⊕
Saint Mary's
HOSPITAL

REFERENCE: License # 06-00679-01 Amendment

We request the following changes to our license:

**Saint Mary's Hospital 2nd Floor
Cardiology Dept**

Policy 7111C ~ Diagram of NM Cardiology Stress Rooms

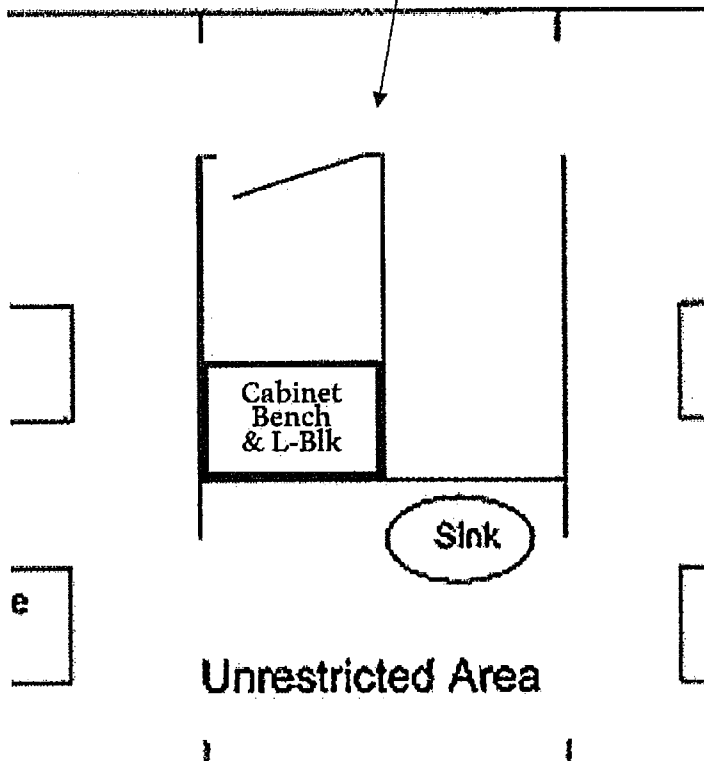
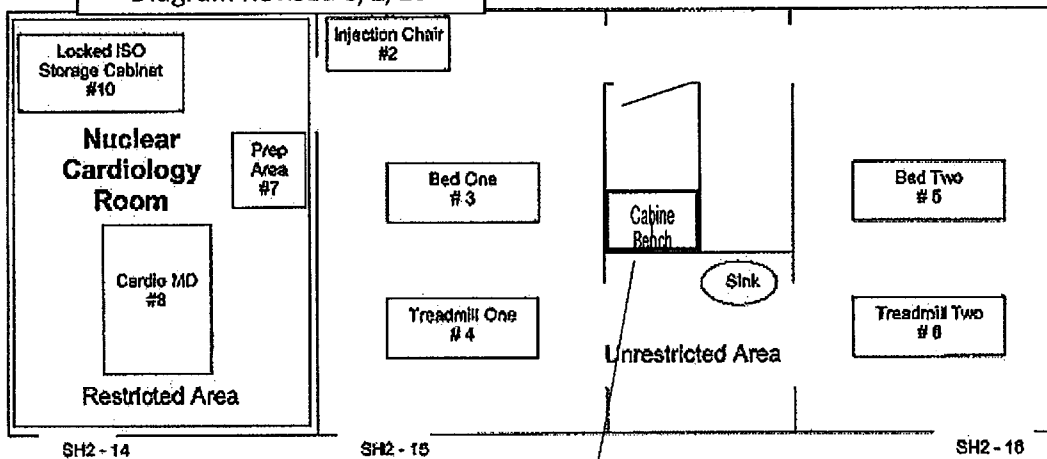
We have modified one dressing room by lining the walls with 1/16" of lead, provided a combination lock on the door, and added a small bench, cabinet, and L-Block. This room will be used for temporary handling and storage of patient doses, storage of a cobalt 57 sheet source, and short term storage of radioactive waste. Door will be kept locked when unattended. Please see attached drawing. Modifications are shown in green.
